March 16, 2023 Ref.: 296704

Re: Public Tender No. PD23000219 (the "Tender") -**Notice Regarding Submission Deadline and Clarifications**

pressure switch (high)

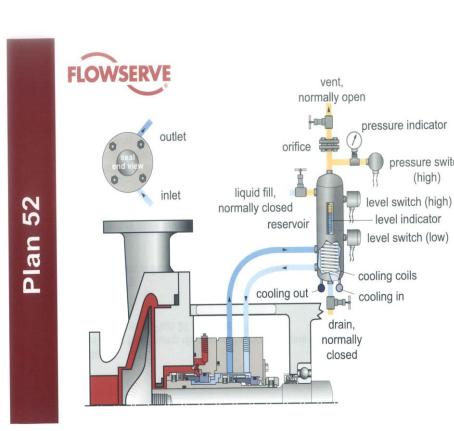
Question	<u>Answer</u>
1	Tender documents section 3.7	Bidder must submit a valid API approval certification for the manufacturing of API-610 pumps. We manufacture and test pump according to API610 standard but has no specific certificate for it.	Manufacturer will perform all tests defined in the API 610 standard. The manufacturer will provide all test data for the customer's reference
2	Specification section 5.7	Mechanical seal: The pump shall be supplied with API 682 double type mechanical seal manufacturer by John Crane or equivalent. The mechanical seal shall be a complete unit including seal flush and external seal quench.	The pump shall be supply with "Dual Seals, Unpressurised, PLAN 52. In addition to the attached plane 52 drawing, the manufacturer shall supply the following items: • Leak Container: Container for collecting leaks from the vent port • The container shall be fitted with leak detection transmitter signal to the central control room • The manufacture will check the possibility of not using water for cooling coils.
